# UNITED STATES PATENT AND TRADEMARK OFFICE

10/801,273

Jaime E. Garcia

<b>Office Action Summary</b>	<b>Application No.</b> 10/801,273	<b>Applicant(s)</b> GARCIA ET AL.	
	<b>Examiner</b> Edward F. Landrum	<b>Art Unit</b> 3724

Modified **FIG. 3**

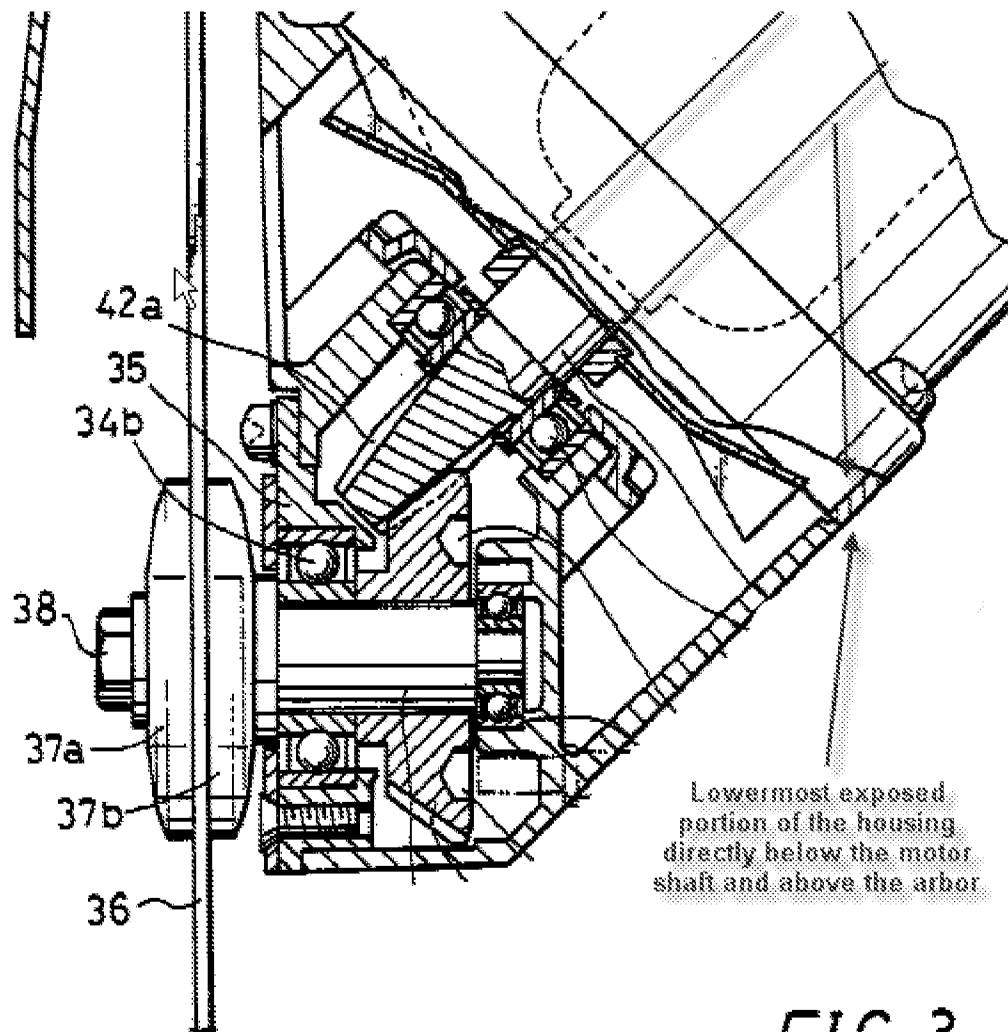
Regarding claim 1, Ito teaches (see Figures 1-3) a miter saw (1) comprising a base (2) having a substantially horizontal turn-table/support surface (3), a work piece positioning fence (6) attached to the base (2), and a cutting assembly (21) pivotally attached to the miter saw. The cutting assembly is pivotable between a raised and a lowered position (see Figures 1 and 2). A motor (41) is drivingly connected to the arbor (33) of the saw blade (36) and configured so as to not contact any portion of the base or fence (6) when the mitering at least 45 degrees from a plane substantially perpendicular to the work piece positioning fence (see Figure 2; Col. 6, lines 1-20). The motor (41) has a motor shaft (42) and a gear assembly (42a and 39) that transfers rotational motion from the motor shaft (42) to the arbor (33). A gear housing (32 and 35) covers the motor shaft, arbor, and gears, and has a lowermost exposed portion directly below the motor shaft (42) and above the arbor when the cutting assembly in the lowered position (see Modified Figure 3 below). The arbor (33) does not extend beyond the motor shaft (42). The gear (39) connected to the arbor (33) is a bevel gear. A blade guard (31) surrounds the blade.

Drake teaches (Figure 2 and 3) that it is inherent in the design of an electric motor that the motor shaft (27 and 28) extends through the motor as this is required for the motor shaft to rotate do to the electromagnetic current created within the motor. Figure 2 of Ito teaches similar structure without explicitly stating it.

Regarding claim 4, Ito teaches (see Figure 3) the gear housing/box (32 and 35) tapers in a direction of the base.

Modified Figure 2.

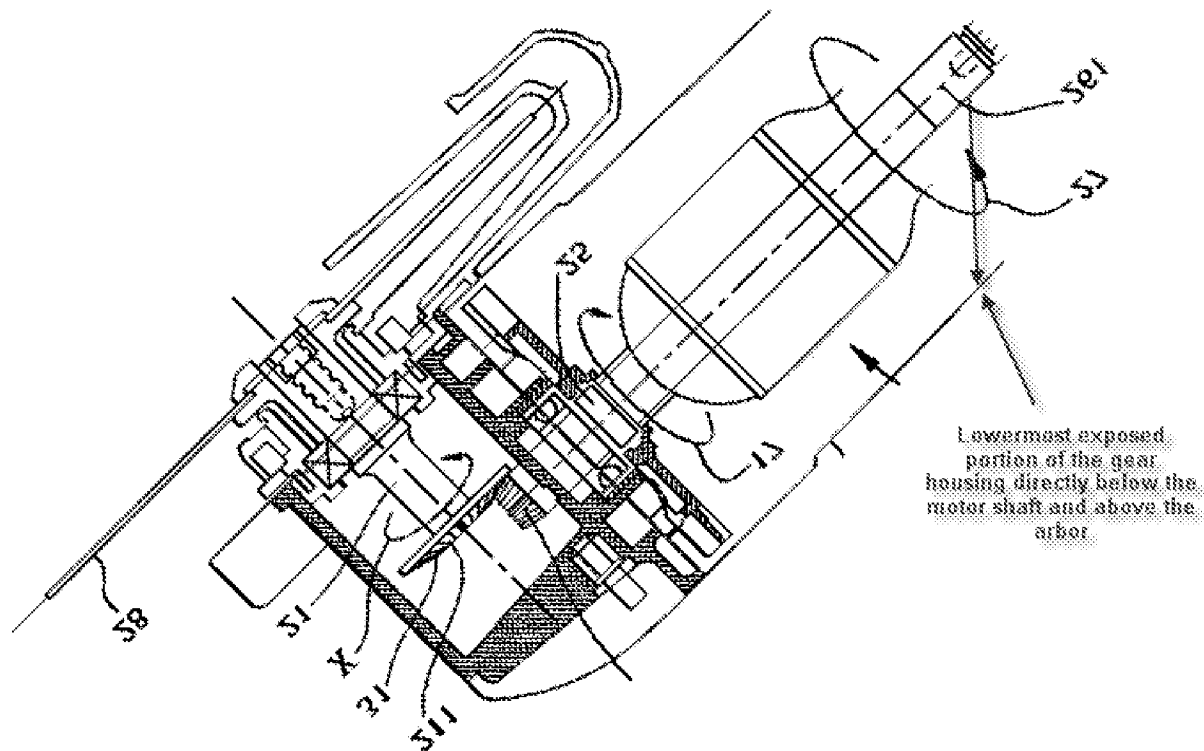
Replacing gear and motor configuration of Hurn in combination with Ito still teaches the limitation of an outer lower most exposed portion of the gear housing being directly below the motor shaft closest to a support surface and above the arbor See modified Figure 2 of Hurn below. The Figure has been reversed and rotated 45 degrees clockwise, which is a possible lowered position of the cutting assembly.

Furthermore, Ito teaches the criticality of allowing the cutting assembly to pivot 45 degrees without contacting the positioning fence (Col. 6, lines 14-19) therefore an outer lowermost exposed portion directly below the motor shaft and closest to the support surface being above the arbor presents no novel or unexpected result over the motor/gear configuration and gear housing of Ito. Use of such a position of the lowermost exposed portion in lieu of the configuration used in Ito would be an obvious matter of design choice to one of ordinary skill in the art.
